CITY OF SOMERVILLE, MASSACHUSETTS  
OFFICE OF STRATEGIC PLANNING AND COMMUNITY DEVELOPMENT  
JOSEPH A. CURTATONE, MAYOR

**Case #:** PB2009-5  
**Site:** Assembly Square Phase 1AA  
**Date:** 8/20/2009  
**Recommendation:** Conditional Approval

## PLANNING STAFF REPORT

**Site:** Assembly Square Phase 1AA (Assembly Square Drive and IKEA)

Lombardi Street at Mystic Avenue North and Assembly Square Drive (Location # 2, Sheets 3 and 4 of 9)

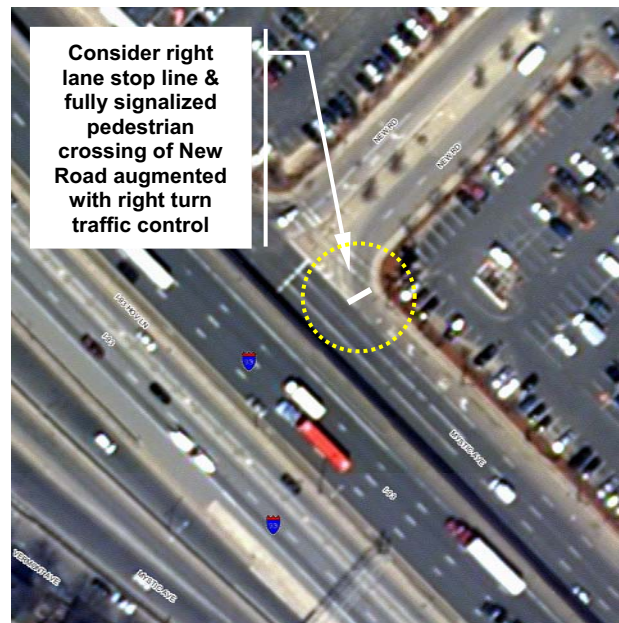
Mitigation proposed at this location includes a relocated and signalized U-turn approach, relocation of the median on Lombardi Street, a new signal phasing and timing plan, new mast arm mounted signal heads serving three approaches, incorporation of an exclusive count-down pedestrian signals, new vehicle detector loops (including bicycles), and installation of a new mast-arm mounted signal to control the relocated U-turn approach. The proposed mitigation plan is beneficial for the northbound Mystic Avenue traffic and the U-turning traffic, as it eliminates the weaving between the stop-controlled U-turning traffic and Mystic Avenue northbound traffic and also reduces the potential for pedestrian and bicycle crossing conflicts.

With the exception of the extension of the median on Lombardi Street as discussed above, the conceptual mitigation plan is acceptable from a traffic perspective. We note that the City Traffic Engineer is recommending that the signal controller at this intersection be replaced. As above, we defer to the City Traffic Engineer's recommendation on this issue with the caveat that the existing controller be recycled for potential use at another location outside the project area.
